# DEVELOPMENT REVIEW COMMITTEE (DRC)

## COMMENT REPORT

**PROJECT NAME:** Fort Lauderdale Police Headquarters

**CASE NUMBER:** UDP-S21029

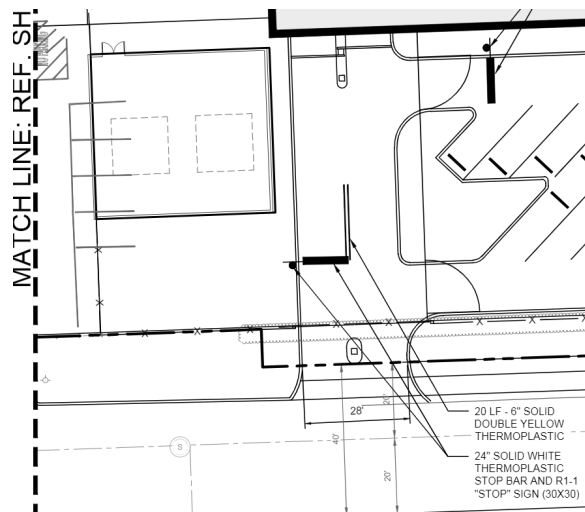
- k. Clarify if fence will divide confiscation parking area on pages PG-A2-01, CM-104 and LP-104 and if there is an opening. See clipped image below.
